15557-TUL-XX-XX-RP-C-91002 Issue 01

Land East of Longwater Road, Finchampstead, Longwater Road, Wokingham, RG40 3TS.

Discharge of Condition Consultation (Application Number 260289)

Planning Response for Conditions 7, 9 & 11.

GUI003-TUL-XX-00-DR-C-95-325

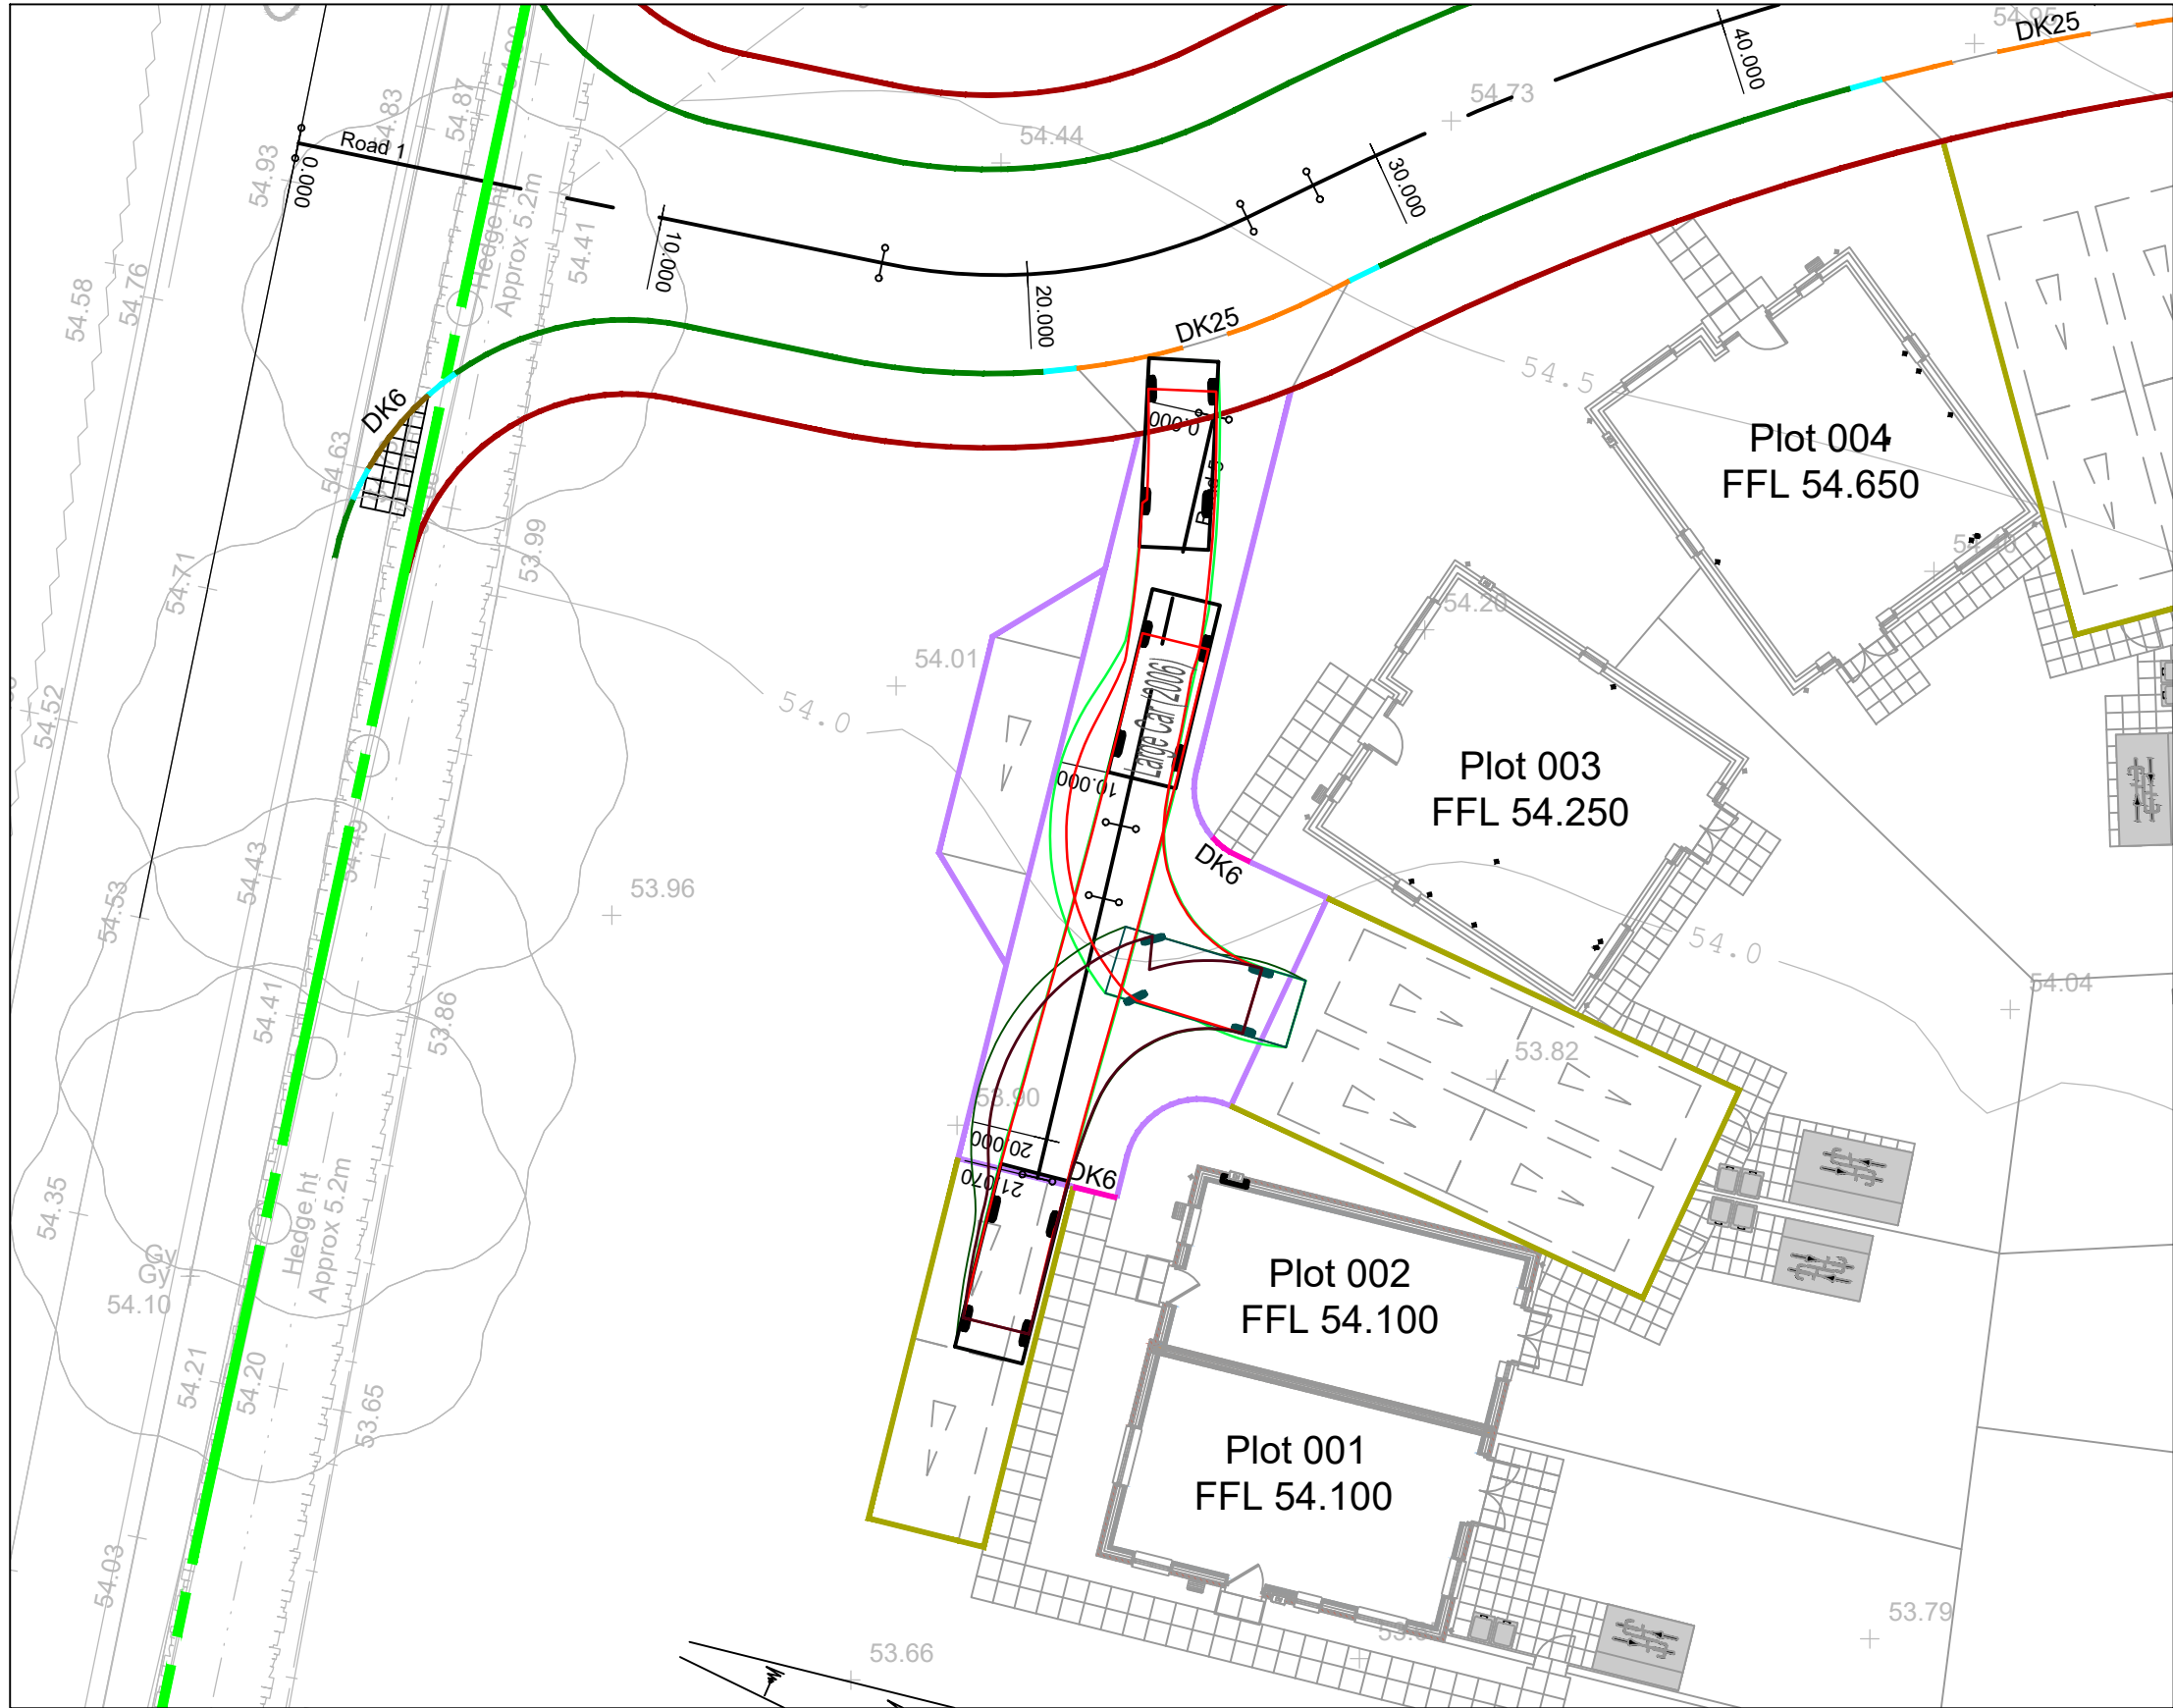
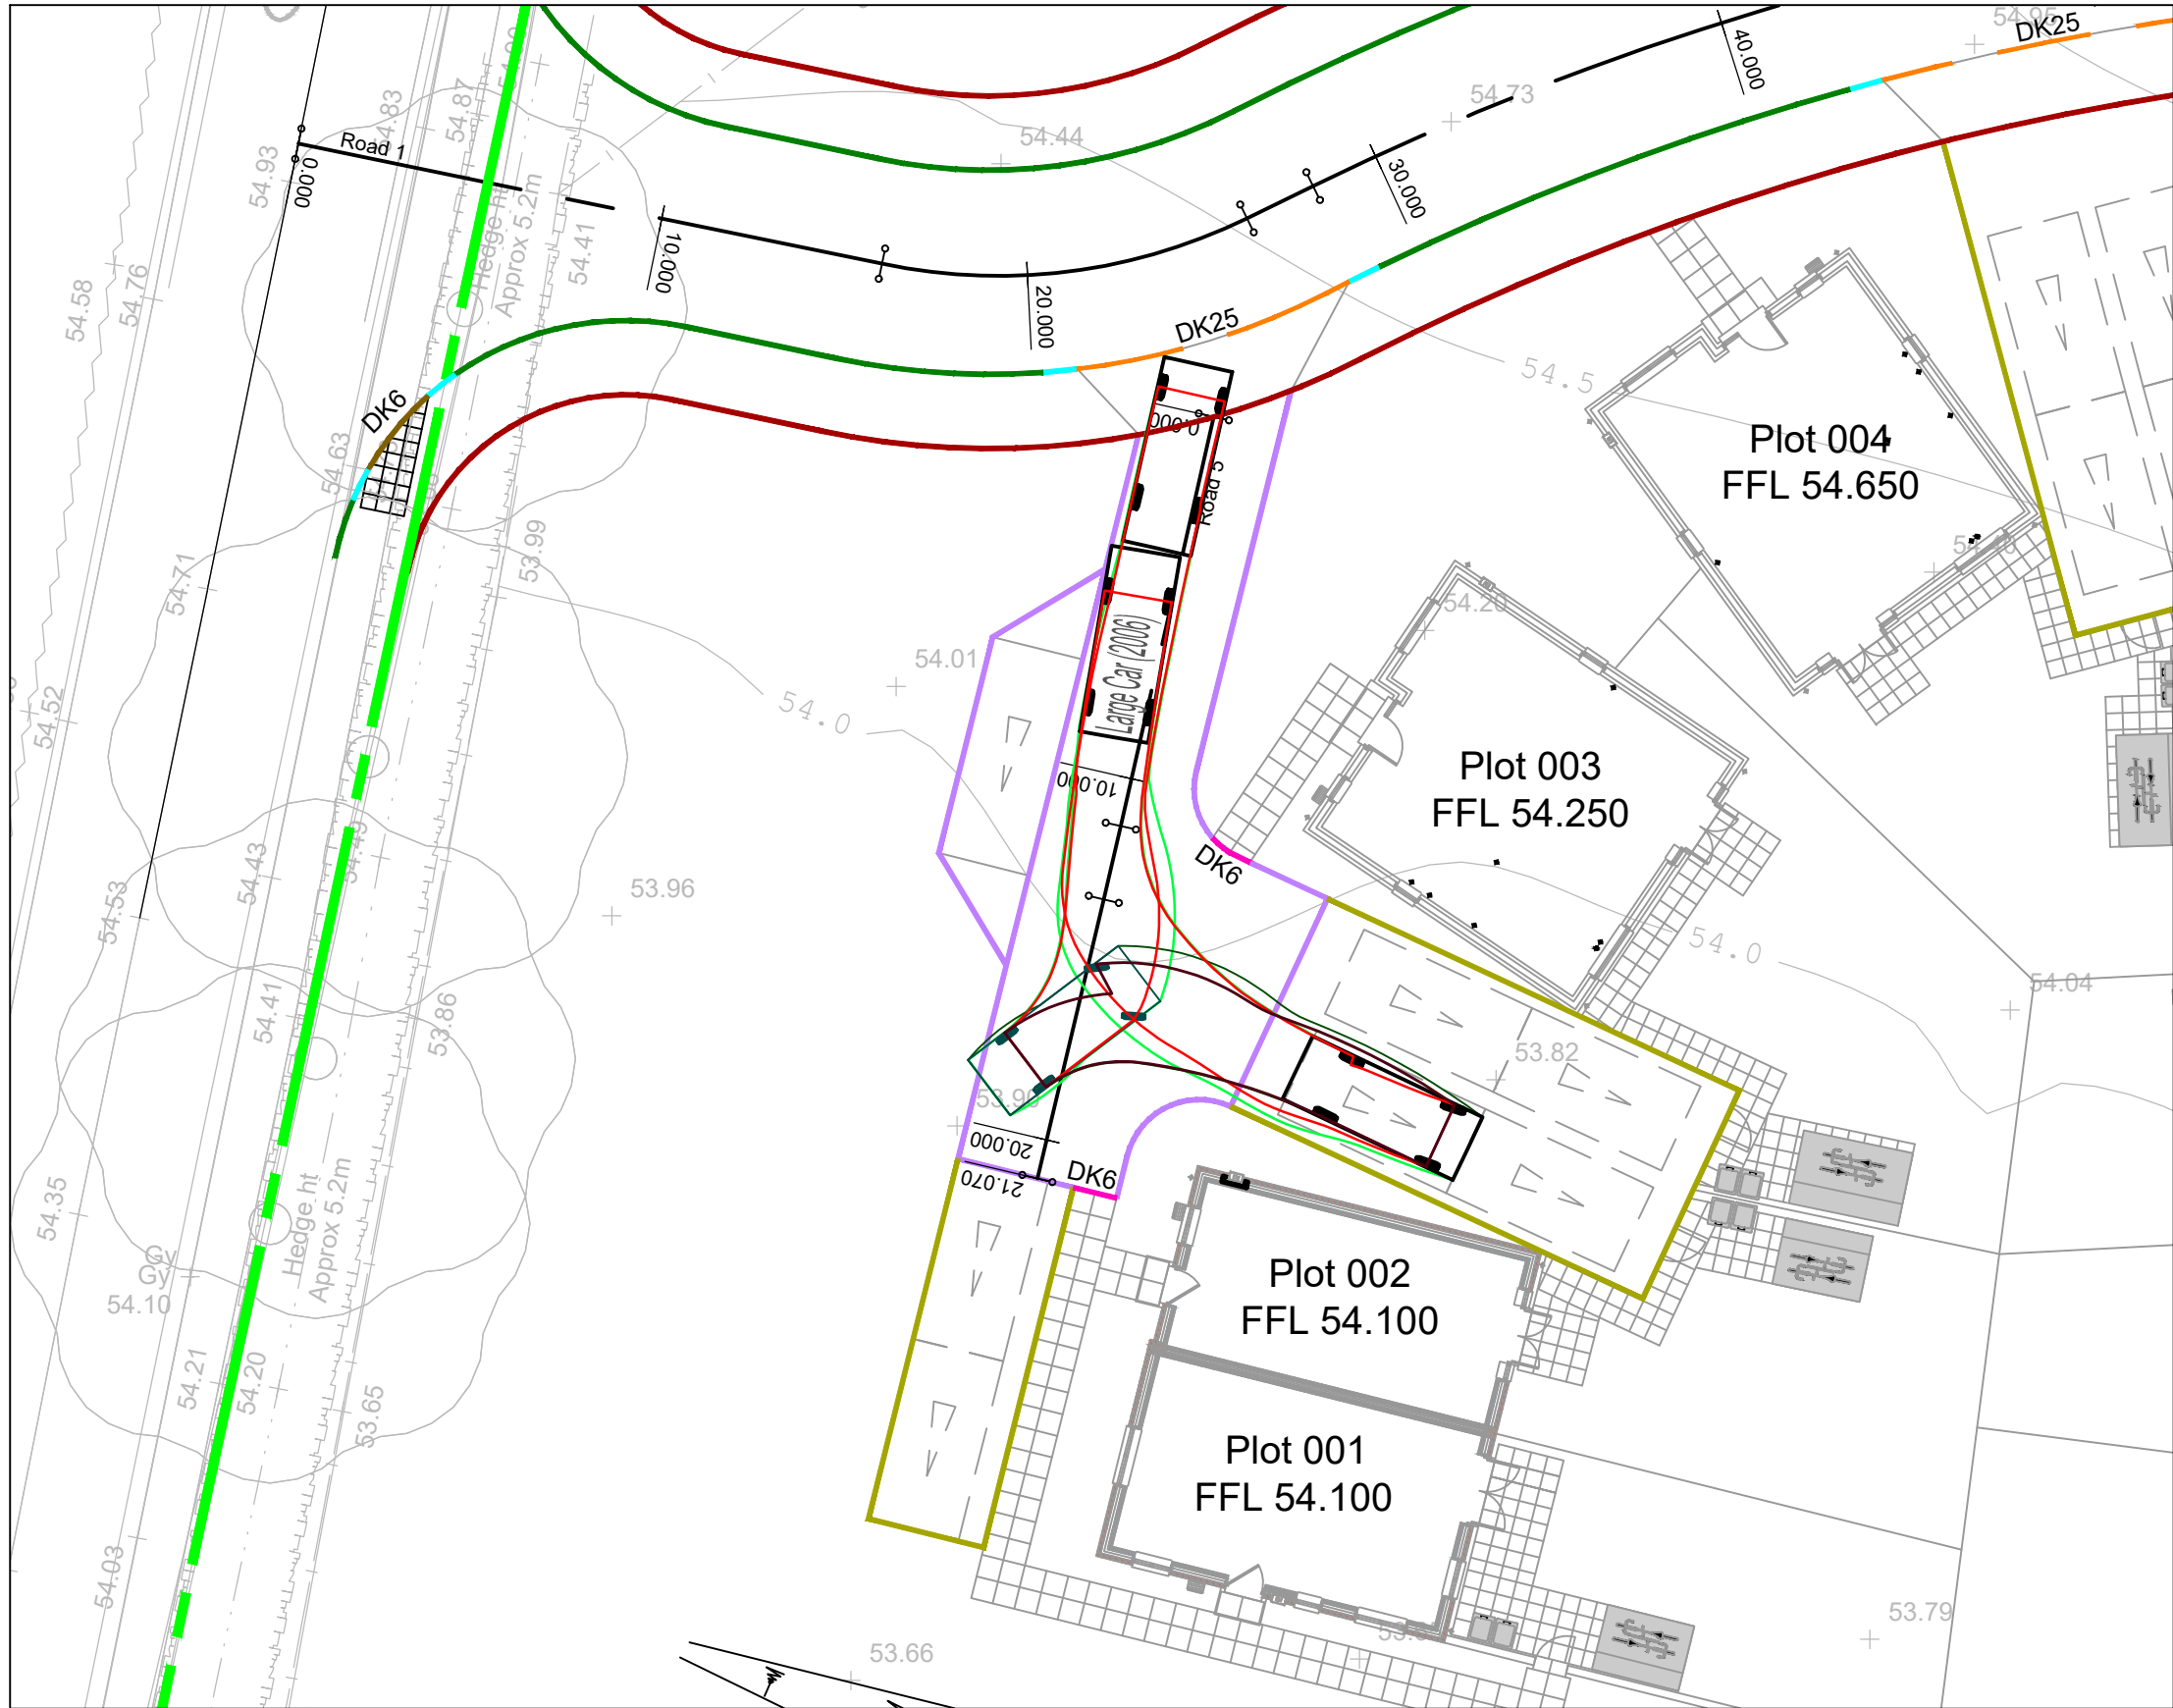
"Highways is concerned that the parking spaces for plots 1, 2 and 3 require the neighbouring parking spaces to be used for manoeuvring. This will need looking at. Highways is content for details of parking to be secured through a planning condition."

The applicant is required to provide a revised arrangement or demonstrate there is sufficient space through swept path analysis of a large saloon car

- *Width of the parking bays proposed on site should be clarified/confirmed.*
- *Swept path analysis is required for the internal roads which show a refuse vehicle and delivery van can pass a large modern car. Swept paths for a large modern car should also be completed for the car parking spaces proposed on site.*

Swept paths undertaken for a Large Car with the following results;

Plot 1 - vehicle can manoeuvre out of parking space in reverse and turn without entering the parking bays of plots 2 and 3.

Plot 2 - vehicle can manoeuvre out of parking space in reverse and turn without entering the parking bays of plots 1 and 3.

Plot 3 - vehicle can manoeuvre out of parking space in reverse and turn without entering the parking bays of plots 1 and 2.

Swept paths shown on drawing GUI003-TUL-XX-00-DR-C-95-325_P01

- Swept paths provided for refuse vehicle and delivery van passing and car for parking spaces.
